**PARK CITY BOARD OF ADJUSTMENT MEETING
SUMMIT COUNTY, UTAH
January 9, 2024**

Board of Adjustment Staff Report

Subject: 948 Woodside Avenue
Application: PL-23-05967
Author: Spencer Cawley, Planner II
Date: January 9, 2024
Type of Item: Variance

Figure 1: Street view of 948 Woodside Avenue (left).

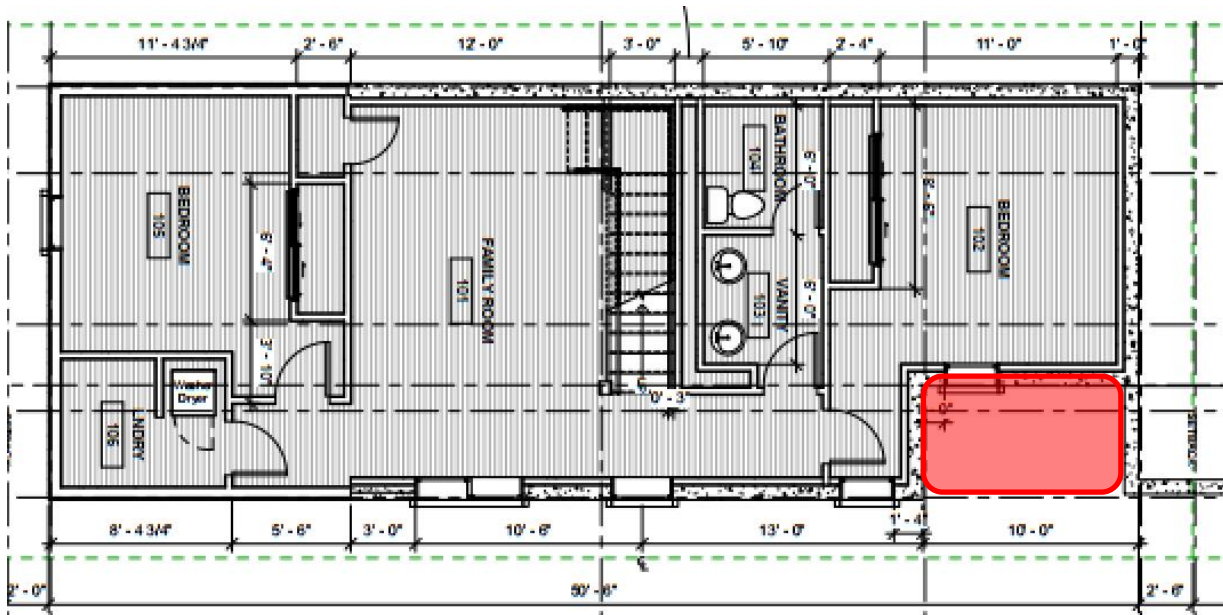
948 Woodside Avenue is a non-historic Single-Family Dwelling located in the Historic Residential – 1 (HR-1) Zoning District. The Applicant is requesting a Variance to increase the Building Footprint of the Structure from 909 square feet to 960 square feet. This Variance is proposed so the Applicant can construct an additional bathroom on the basement level so that there will be two bathrooms for the three basement-level bedrooms. The Applicant requests a Variance to increase the maximum Footprint of the building to accommodate this second basement-level bathroom.

The Building Footprint of 948 Woodside Avenue has not changed since 1992. When constructed, the basement level was constructed with an exterior area considered outside of the Building Footprint as shown in the as-built drawing provided by the Applicant (Exhibit B). The exterior area is highlighted in red:

Recommended Finding: The Applicant proposes a Variance from the Maximum Building Footprint to construct a 51-square-foot bathroom addition. However, this Lot is not an unusual lot in the HR – 1 Zoning District. Rather, Woodside Avenue is a typical Old Town Lot: 25 feet wide by 75 feet deep, with a total Lot Area of 1,875 square feet. The Maximum Building Footprint Formula established in the LMC for an HR – 1 Zoning District Lot containing 1,875 square feet is 843.75 square feet and is applied to all HR – 1 Zoning District Lots. The existing Building Footprint is 909 square feet, already exceeding the Maximum Building Footprint by 65.25 square feet. The requested Variance would increase the excess Building Footprint to 116.25 square feet. Literal enforcement of the Land Management Code would not cause an unreasonable hardship for the Applicant. The existing Structure has three bathrooms.

INDENTATION

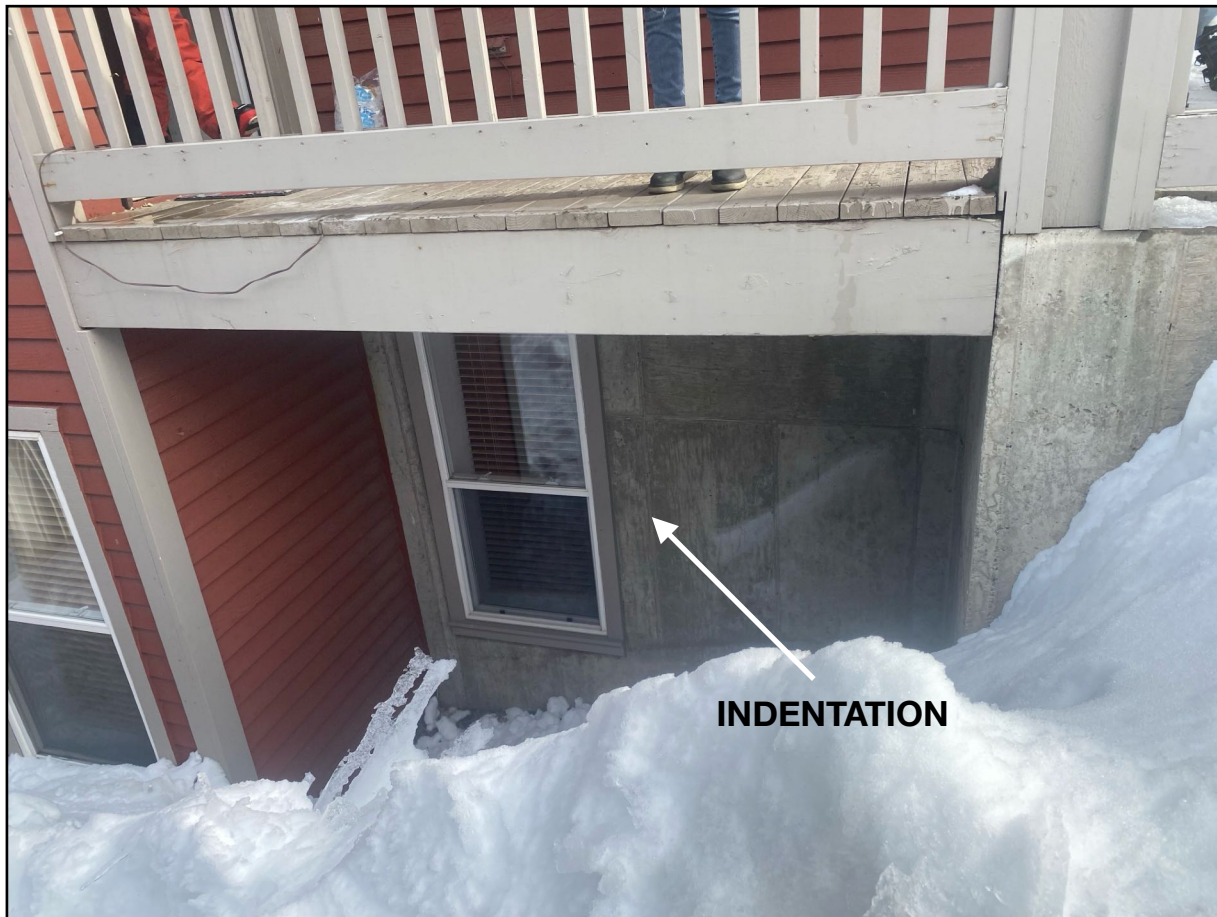
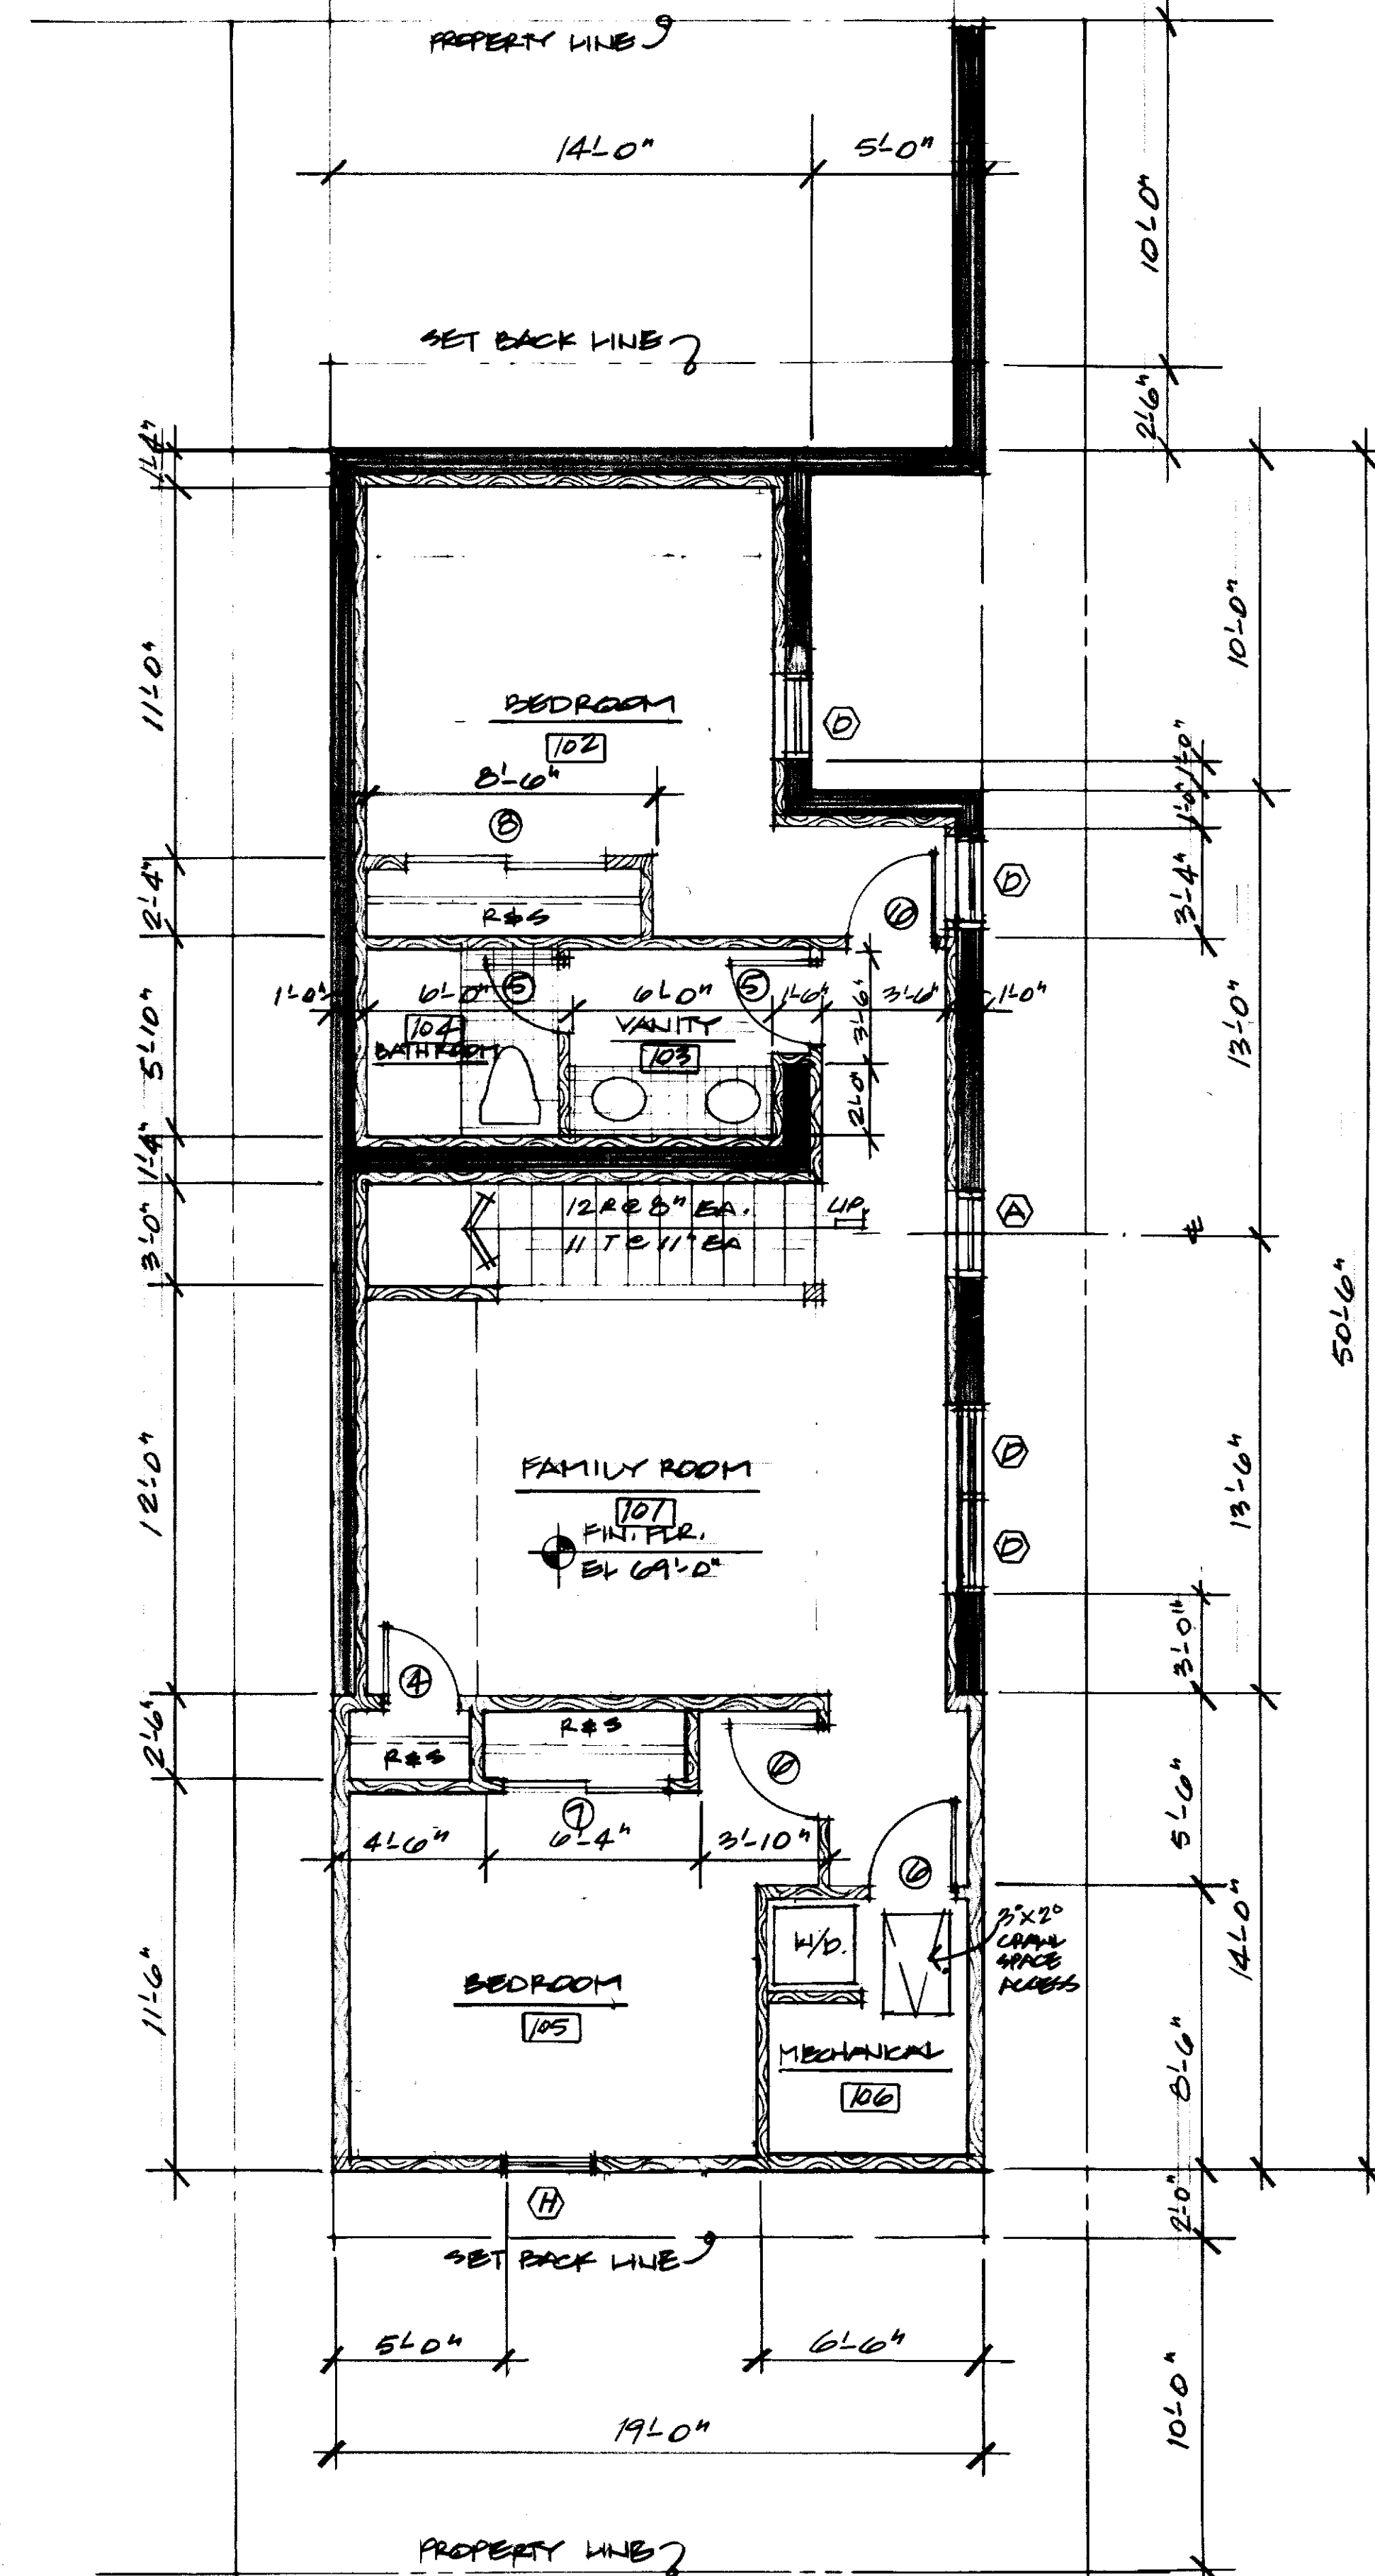
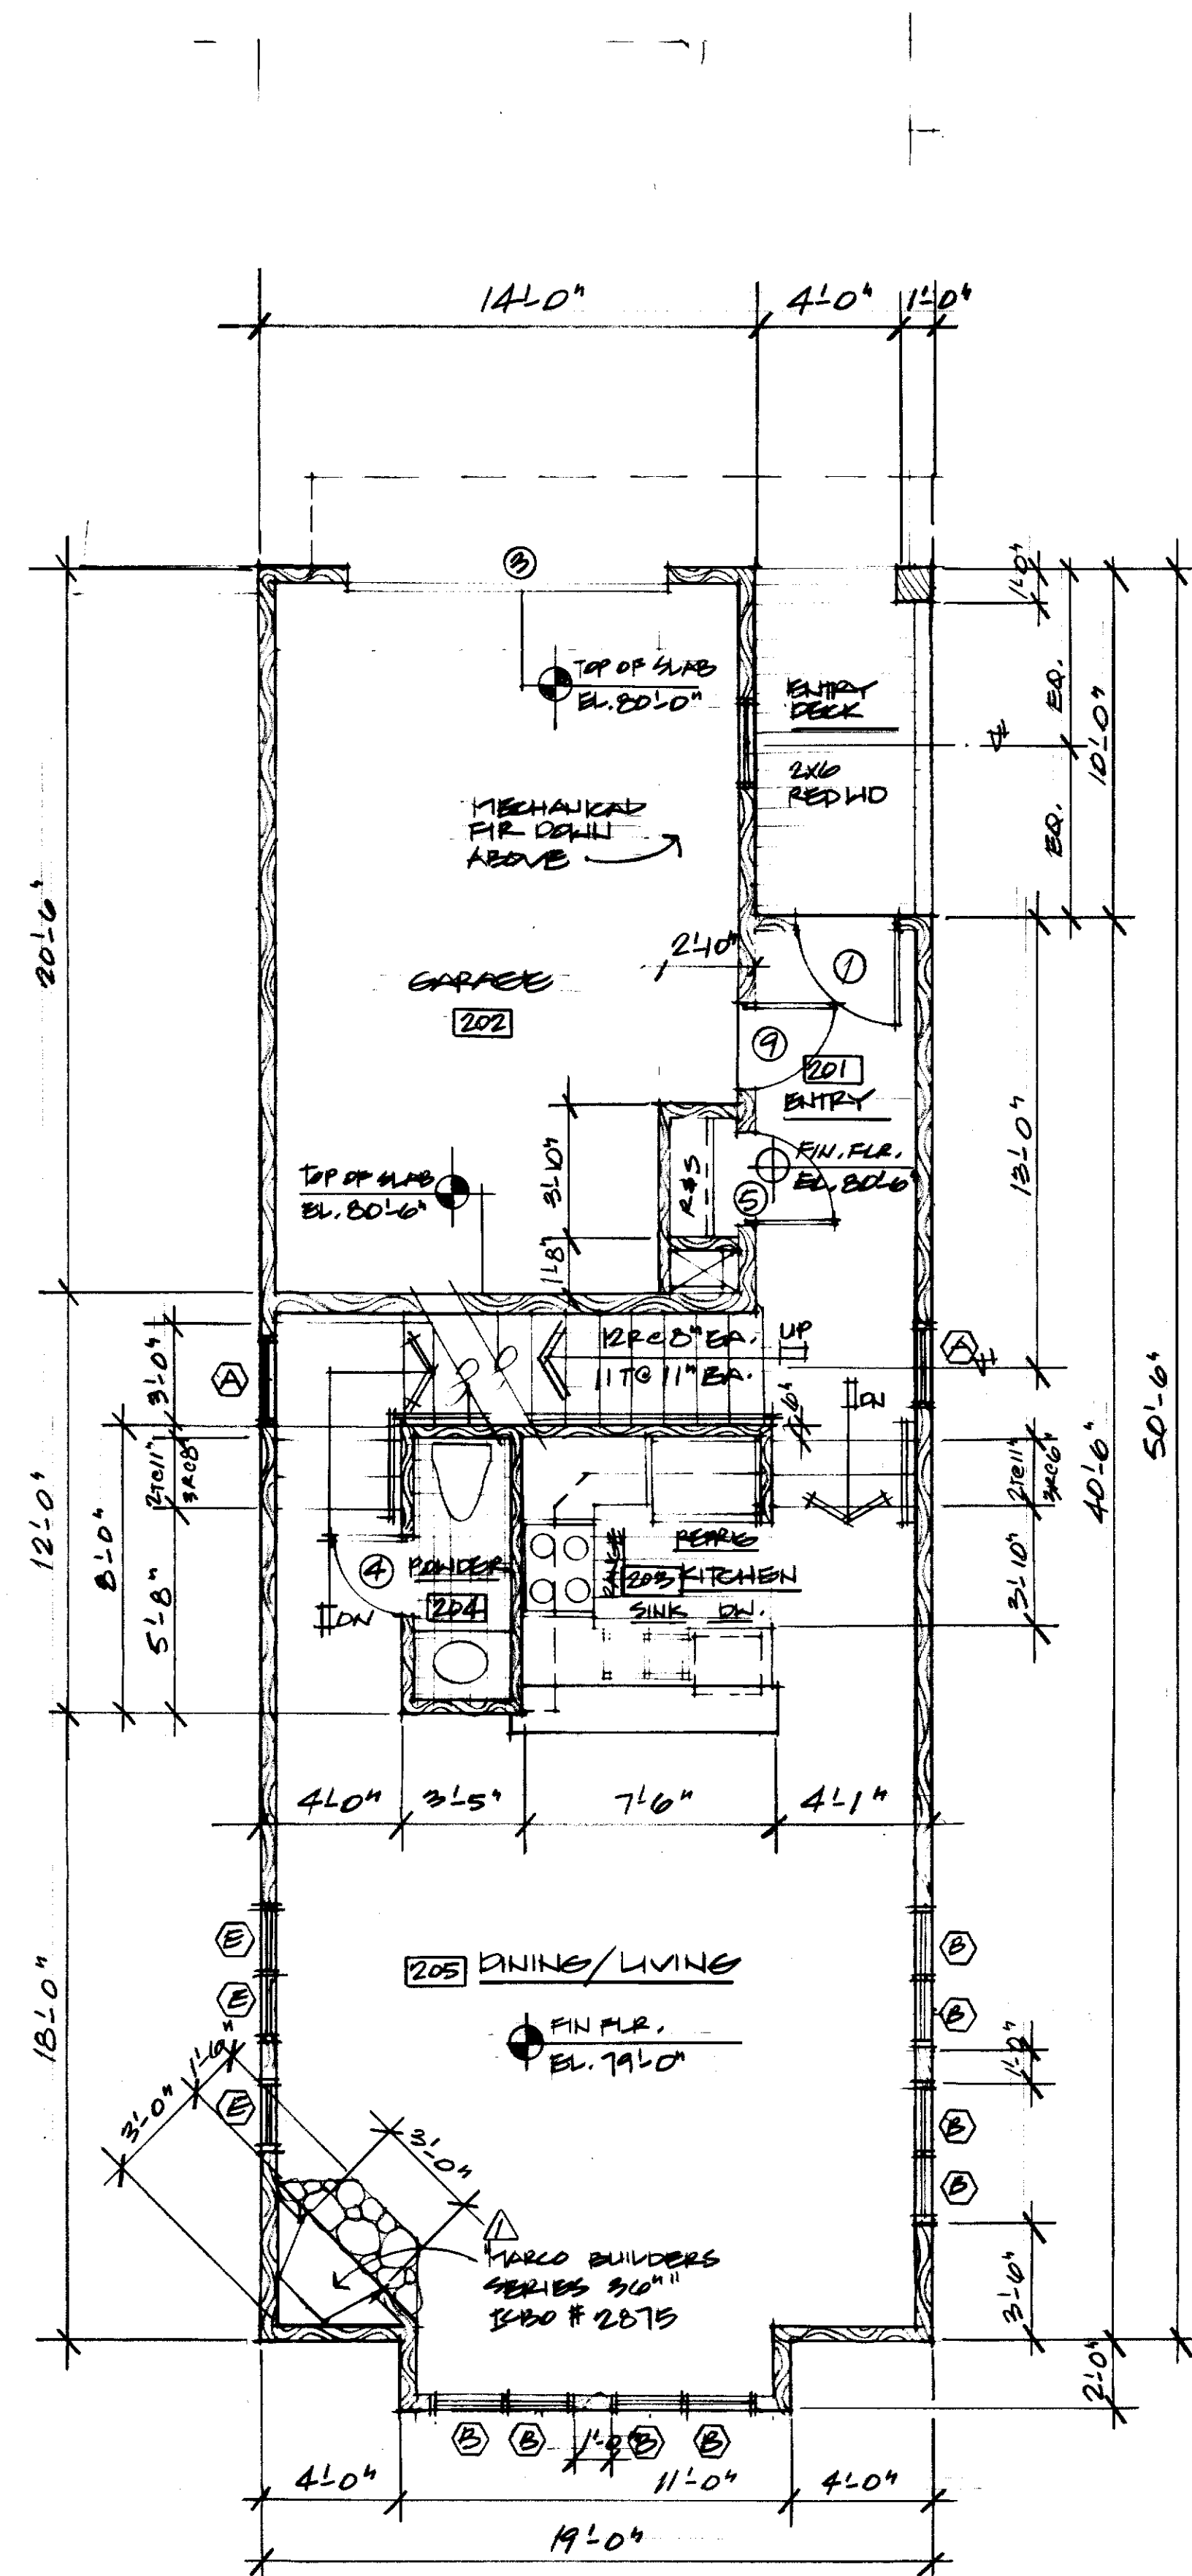
2. There are special circumstances attached to the Property that do not generally apply to other Properties in the same zone.	Applicant's Response: <i>The Applicant's request is to create a bathroom where the indentation exists in the grade-level foundation [which is] unique to 948 and 946 Woodside (mirrored homes built at the same time) and differs from other homes in the neighborhood. One goal is no longer to have twin homes but differentiate the two homes. The grade-level foundation is unique to both 948 and 946 Woodside</i>

<i>and differs from other lots in the area due to the individual lot's narrow dimensions. Currently the building footprint for 948 Woodside is a rectangle that includes a small "indentation" below grade on the front left side of the house (5' x 10') The original reason of the indentation is unknown; however, it is speculated that it may have been intended for the addition of an outdoor A/C/ condenser. The requested modification will not extend the footprint however it will "fill-in" the "indentation" and make the footprint a perfect rectangle. By enclosing the below grade indentation [the Applicant] will be adding ~50 square feet to the footprint square footage. The enclosed space will be used to provide a small basement bathroom to service one of the three basement rooms.</i> <u>Recommended Finding:</u> 948 Woodside Avenue has a slope of less than 14%. LMC <u>§ 15-15-1</u> defines Steep Slope as a slope greater than 15%. 948 Woodside Avenue is, therefore, not impacted by Steep Slope considerations. The Property is not near a wetland or stream. The Structure is not designated a Historic Structure on the Park City Historic Sites Inventory. As a result, no special circumstances are attached to the Property that do not generally apply to other Properties in the same zone.

4. The Variance will not substantially affect the General Plan and will not be contrary to the public	<u>Applicant's Response:</u> <i>This small indentation in the footprint is below grade and not seen from the road or other properties. The second and third floors of the home have already</i>

interest.	<i>been built above this “indentation”, so it appears from the street view that the space is already being utilize[ed] where the indentation exists. Again, since the home’s levels above the “indentation” are over said “indentation” the casual observer assumes it does not exist.</i>  <u>Recommended Finding:</u> Historic Character is one of the core community values outlined in the General Plan. Goal 15 of the General Plan is to preserve the integrity, mass, scale, compatibility, and historic fabric of the nationally and locally designated historic resources and districts for future generations. Objective 15B is to maintain the character, context, and scale of local historic districts with compatible infill development and additions. The HR – 1 Zoning District maximum Building Footprint is established in part to support compatible infill in the City’s Historic Districts. Allowing a Building Footprint that already exceeds what is allowed to increase the non-conformity is contrary to Goal 15 of the General Plan and does not preserve the integrity, scale, compatibility, and historic fabric for future generations.

Objective 15B is to maintain the character, context, and scale of local historic districts with compatible infill development and additions. The HR – 1 Zoning District maximum Building Footprint is established in part to support compatible infill in the City's Historic Districts. Allowing a Building Footprint that already exceeds what is allowed to increase the non-conformity is contrary to Goal 15 of the General Plan and does not preserve the integrity, scale, compatibility, and historic fabric for future
